Milford Police Department
401 NE Front Street Milford, Delaware
Project No. 2019030.00
Bid Pac A – Contracts 1 thru 17
March 4, 2022

Addendum No. 2

Addendum No. 2 consists of:
RYJ Written directive (4 pages)
BMG Written directive (2 pages)
Construction Drawings (See BMG directive for list) (24 Drawings)

UTILITIES PLAN

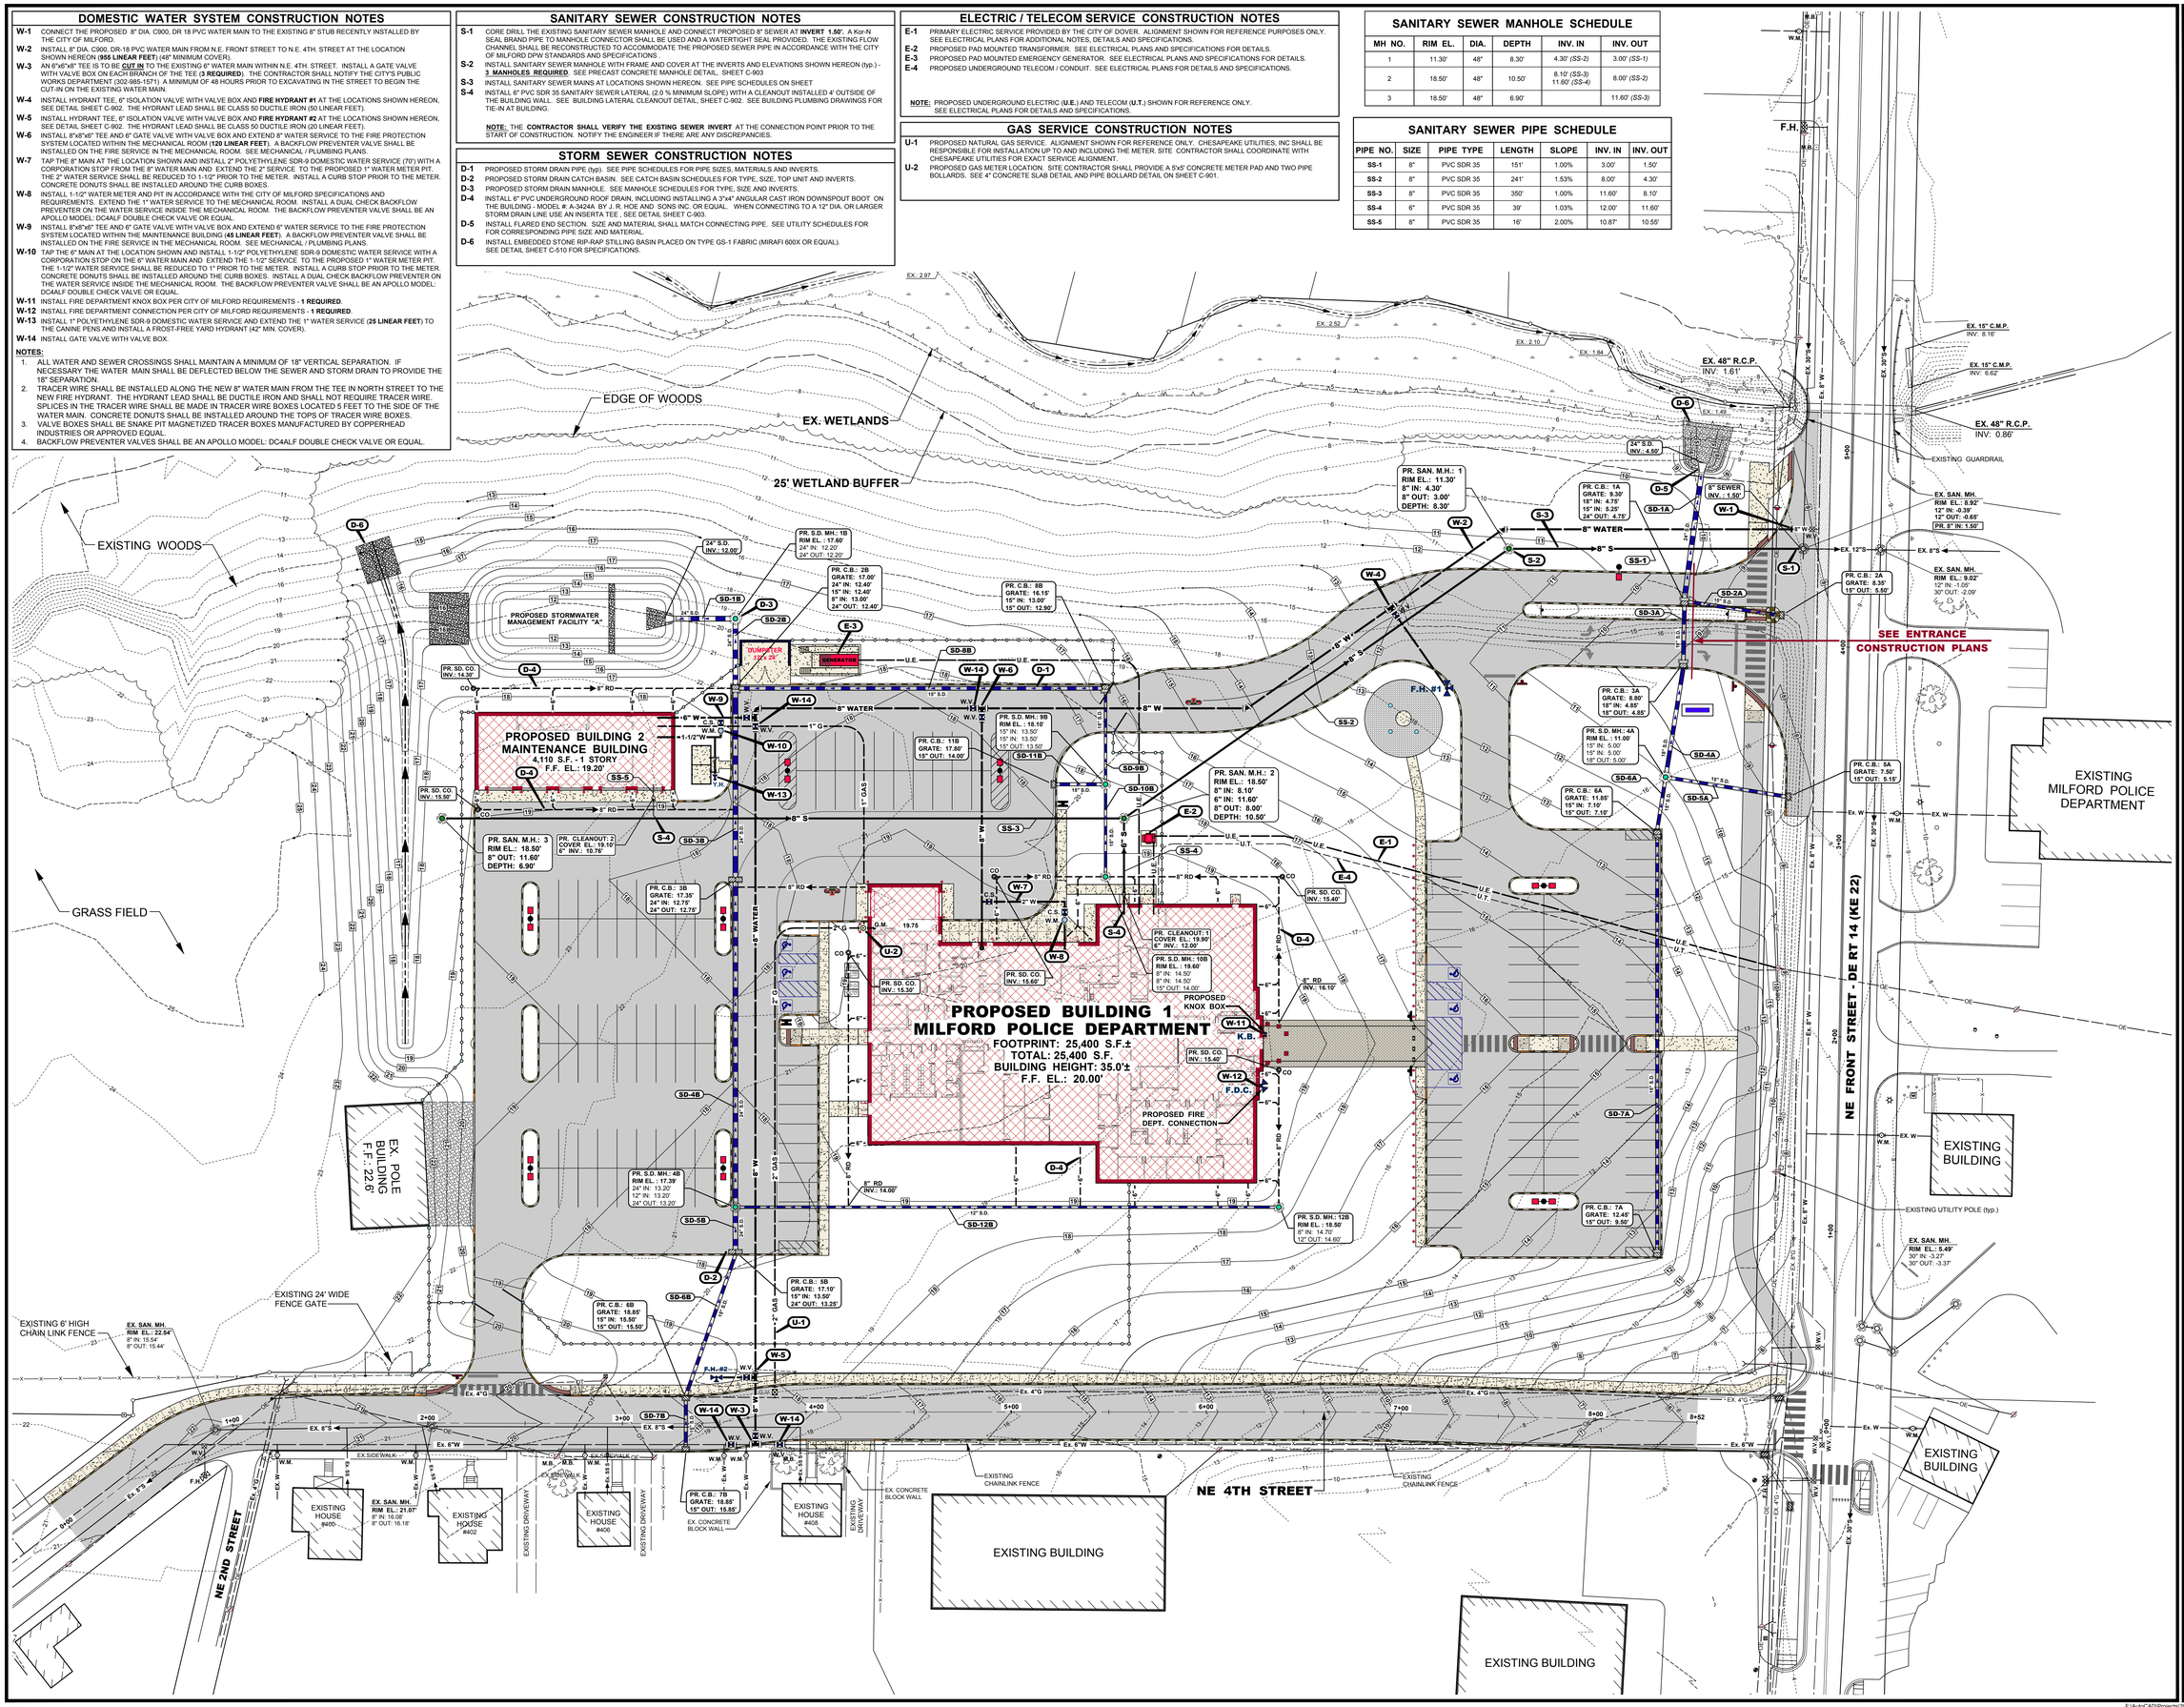
Question:
On Civil Drawings For W-3 it says to do a 12x8 wet tap but the plan shows the main being a 6" not 12", has the main been updated and the plan doesn't reflect this.
Answer:
Best available records show the water main is 6" diameter. Note W-3 shall be revised to a 6" dry connection utilizing tee connection with valves installed on each branch of tee; see drawing C301, Addendum 2, dated 03/04/2022.

DATE:	REVISION NO.:	APPROVED:
CITY OF MILFORD DEPARTMENT OF PUBLIC WORKS WATER & WASTEWATER DIVISION CONSTRUCTION STANDARDS		1" WATER METER SERVICE CONNECTION NO SCALE
		SECTION - 2 | DRAWING: D2-2

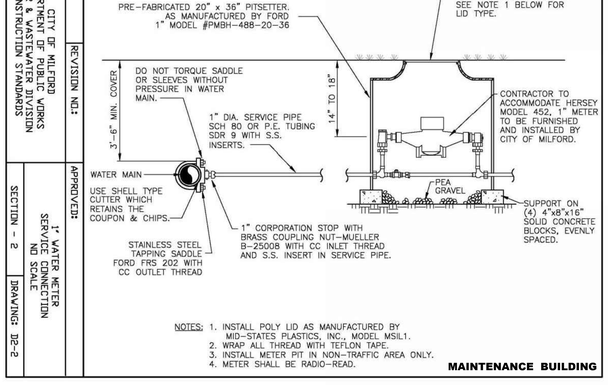
6. C902 - 1" Water Meter and 2" Water Meter details added.

WATER MAIN / UTILITY CROSSING DETAIL

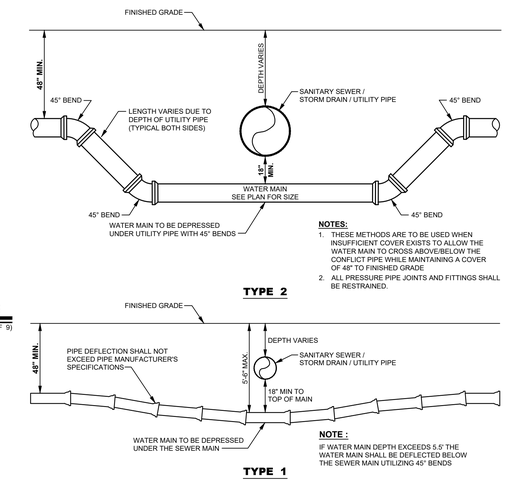
7. C903 – Building Lateral Cleanout Detail and Water Main/Utility Crossing Detail moved from sheet C902 to C903.
8. S101 – FOUNDATION PLAN
    a. ADD Section cuts 10/S201 and 7/S301

P1 / S101 FOUNDATION PLAN
1/8" = 1'-0"

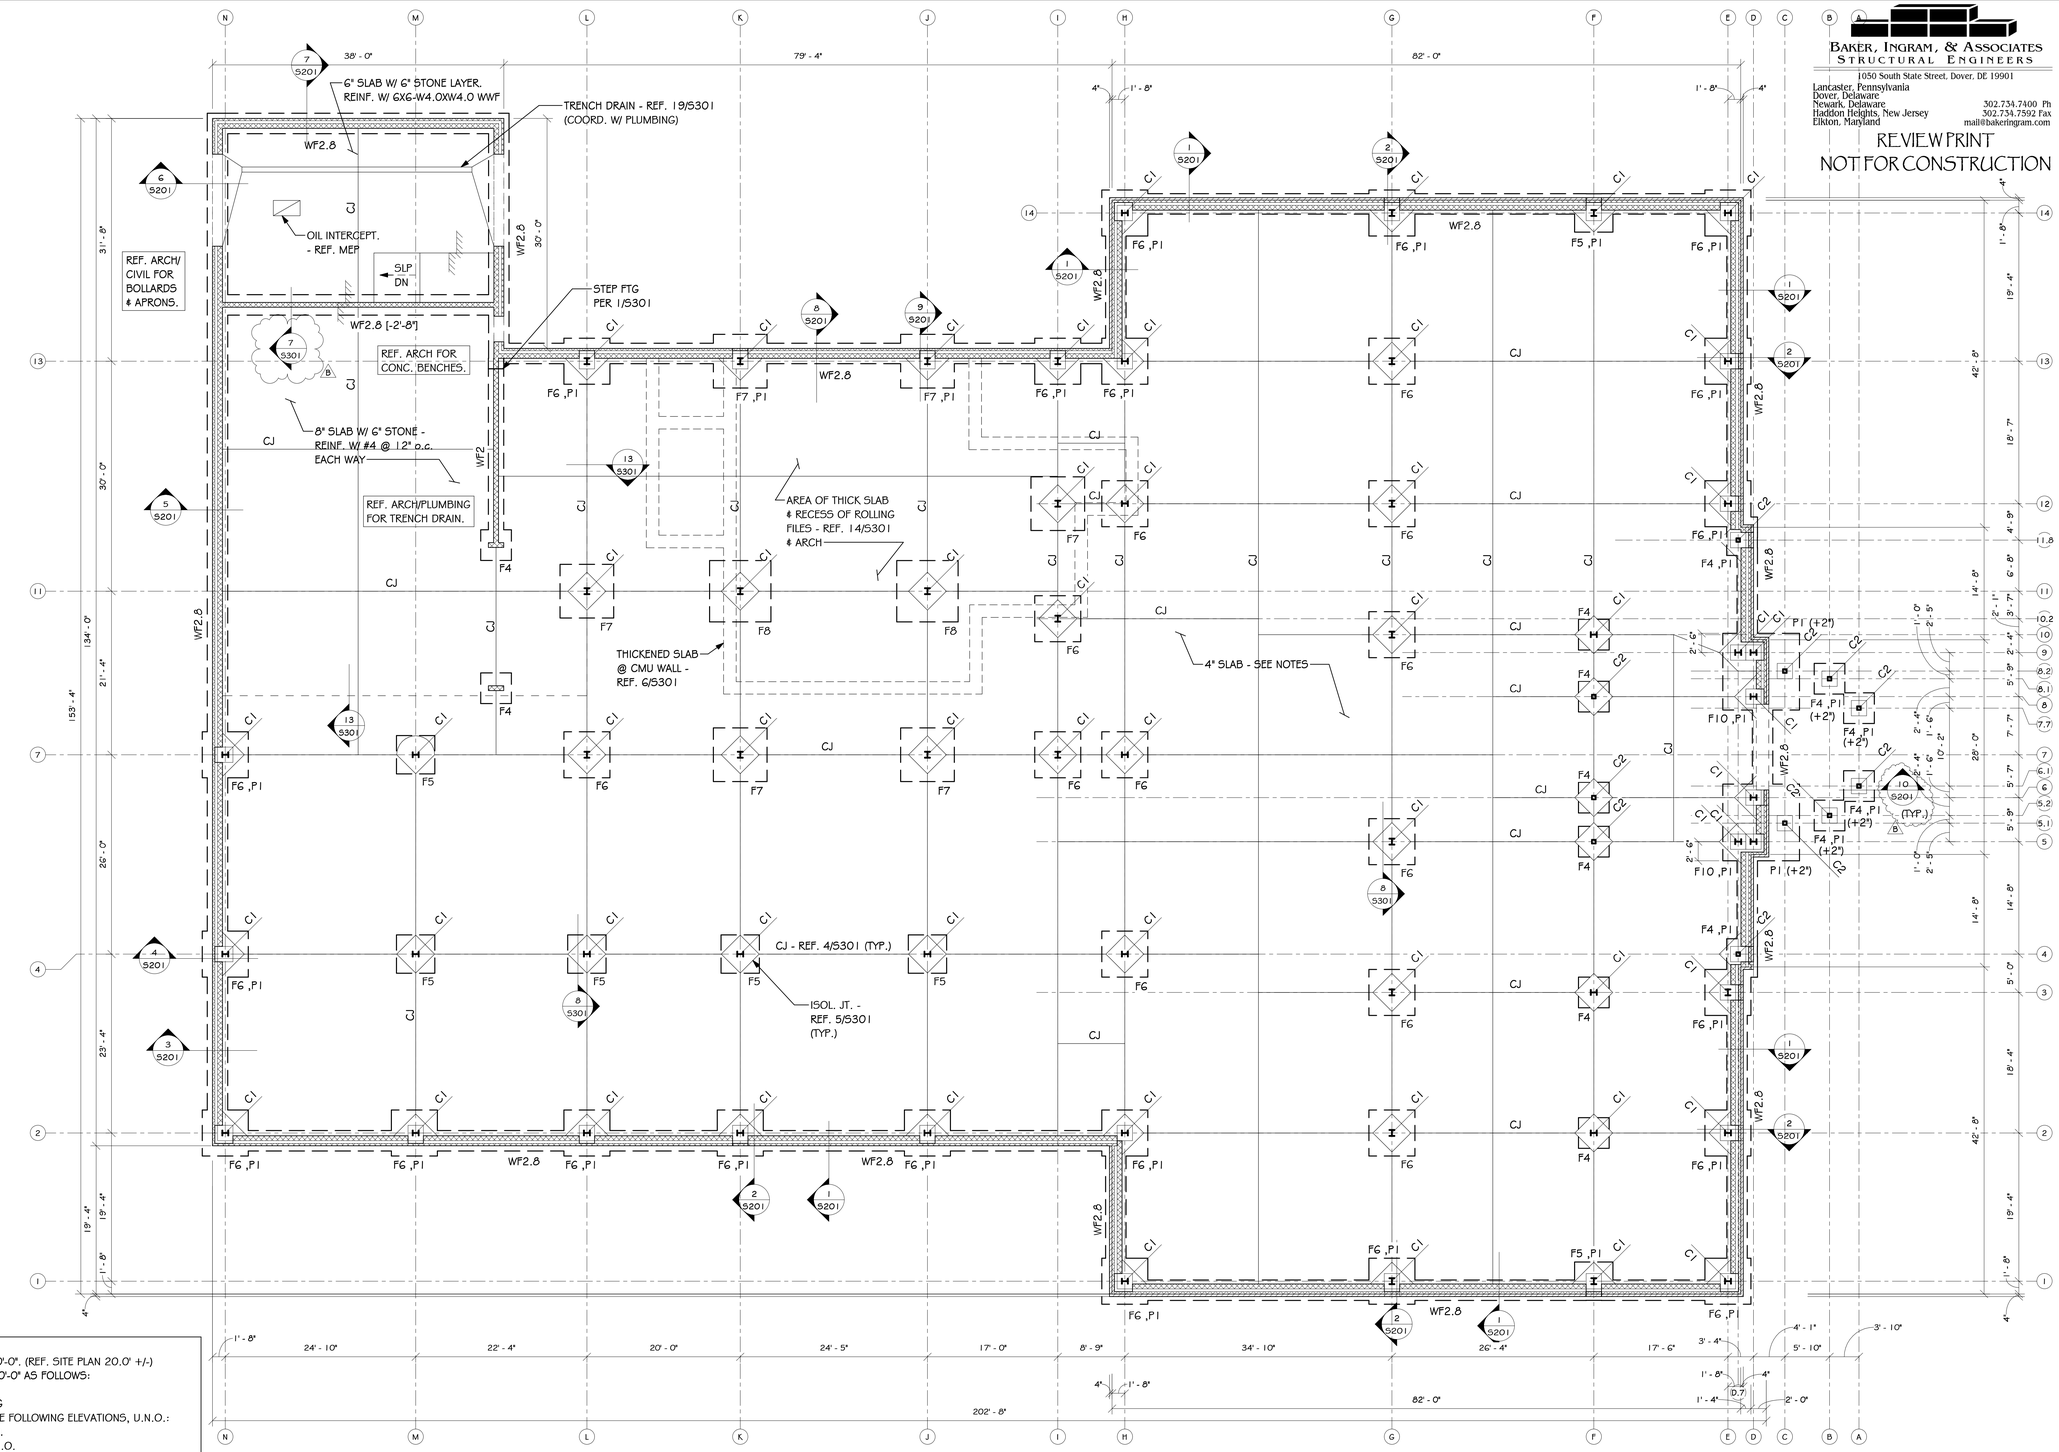
b. Reinforcement changes in Footing F5
9. S102 – ROOF FRAMING PLAN
    a. ADD lateral movement connections at 2 beams
    b. ADD section cuts 15, 16, 17/S202

7 5301 SECTION
3/4" = 1'-0"

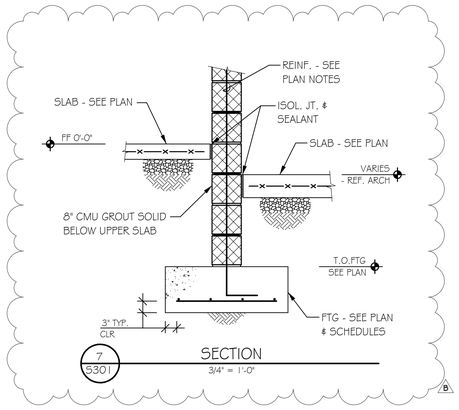
10. S201 – TYPICAL SECTIONS & DETAILS
    a. ADD detail 10/S201
11. S202 – TYPICAL SECTIONS & DETAILS
    a. ADD details 15, 16, 17/S202
12. S301 – TYPICAL SECTIONS & DETAILS

a. ADD detail 7/S301
13. A001 – CONSTRUCTION TYPES – EXTERIOR WALLS, SLABS, FLOORS, ROOFS, AND SOFFITS
    a. Wall Type 8A: ADD notes at transition of brick to EIFS and EIFS on CMU.

1 FIRST FLOOR FINISH PLAN
SCALE: 1/8" = 1'-0"

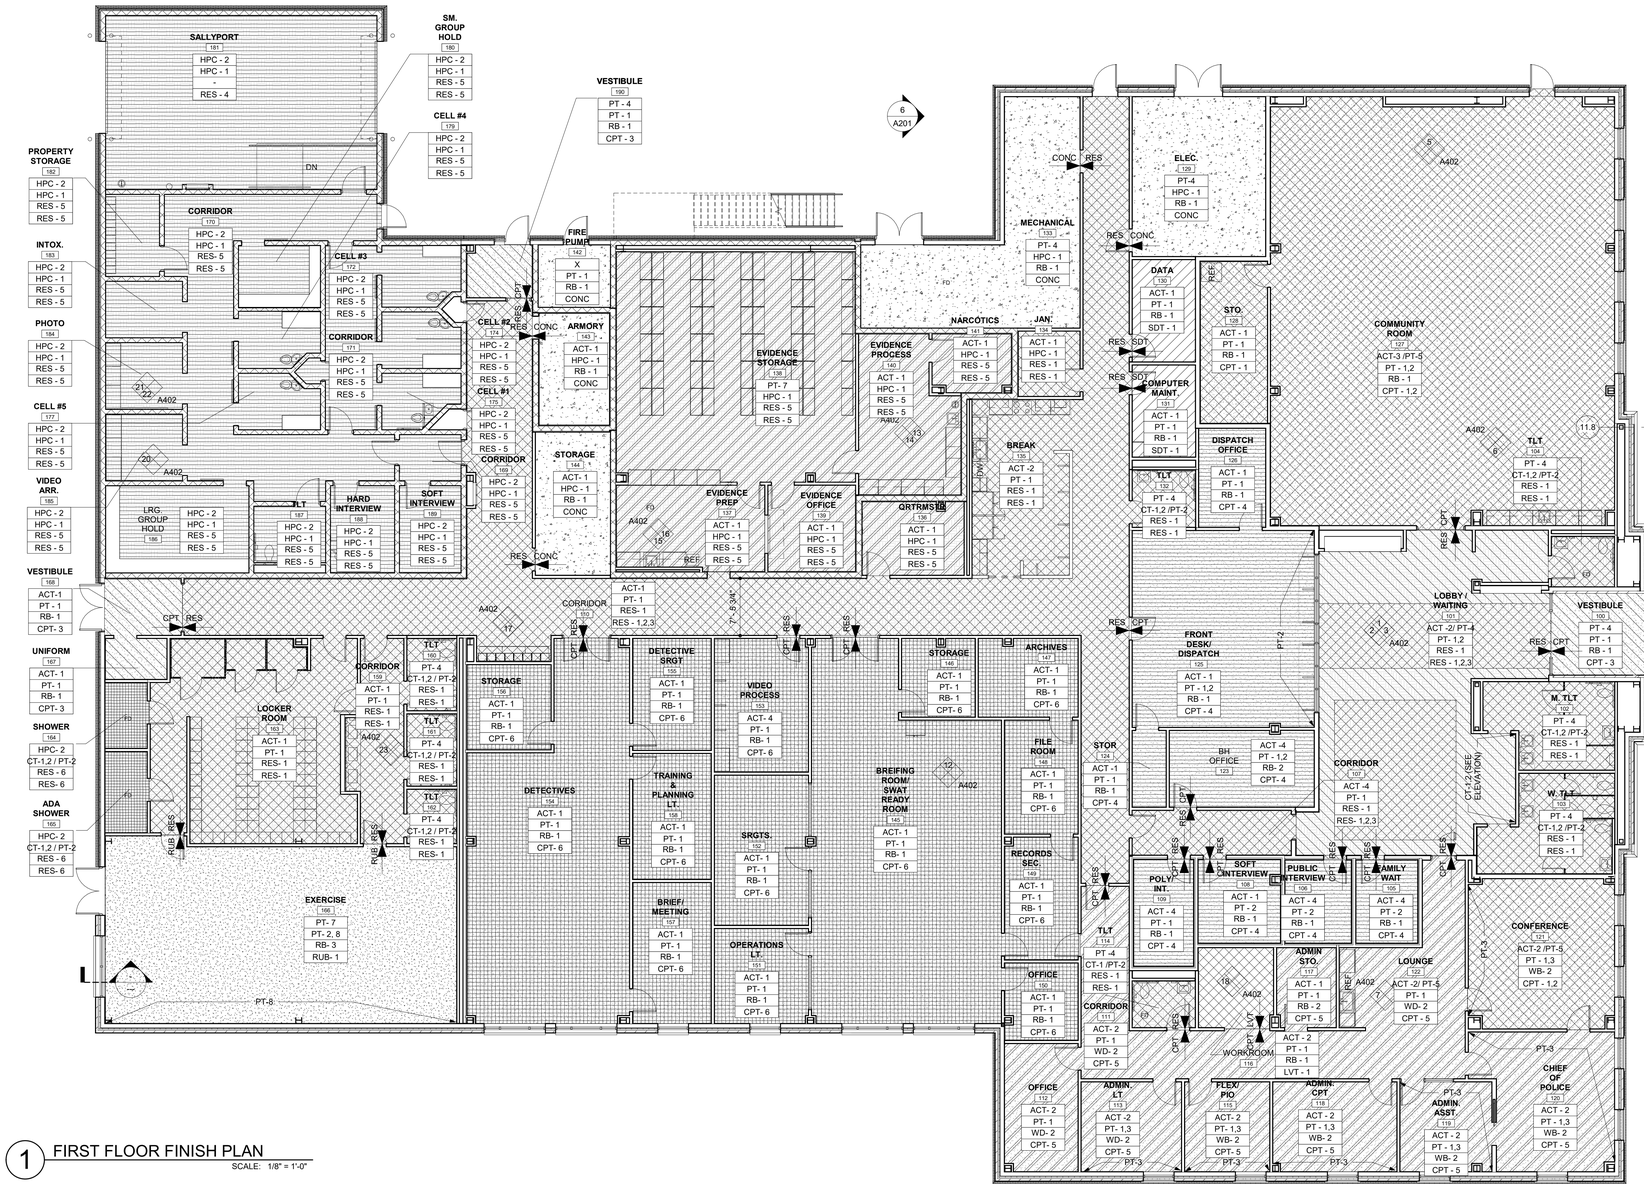
b. ADD special shaped brick profiles.
    c. UPDATE slab types 1, 2, 3 notes
14. A105 – FINISH FLOOR PLAN
    a. ADD General Finish Plan Notes
15. A202 – EXTERIOR ELEVATIONS

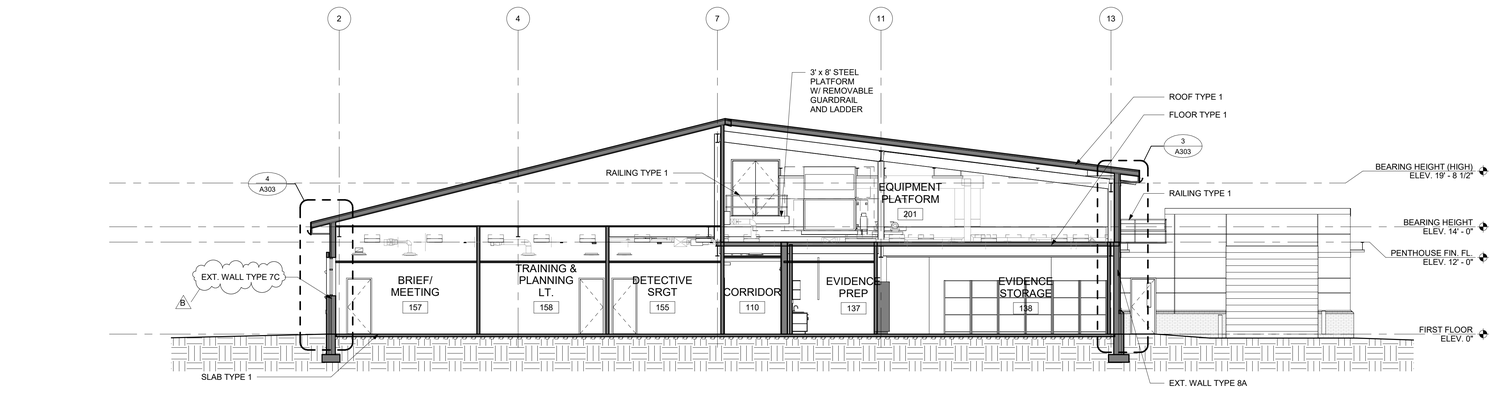
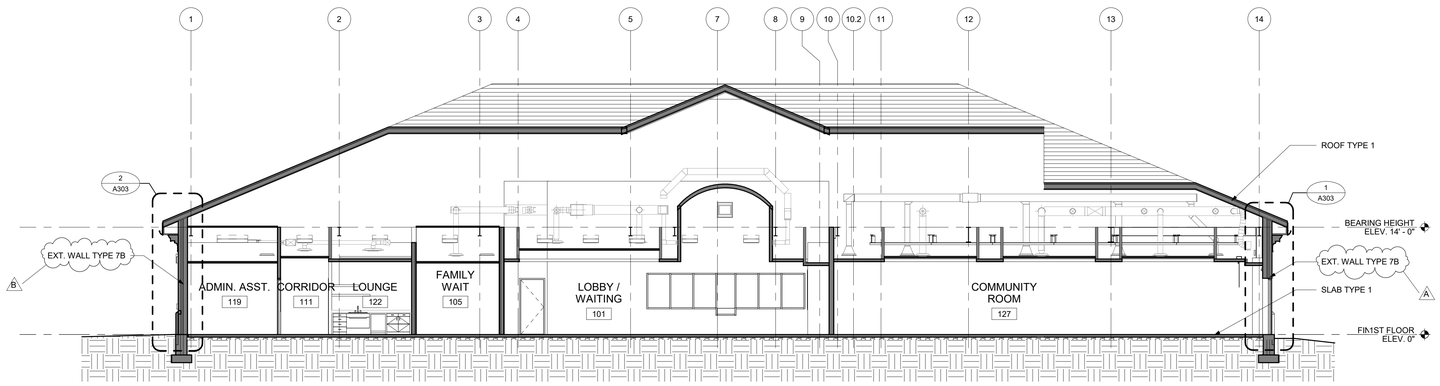
a. REVISE character lettering note
16. A301 – BUILDING SECTIONS
    a. UPDATE exterior wall types
17. A302 – BUILDING SECTIONS
    a. UPDATE exterior wall types
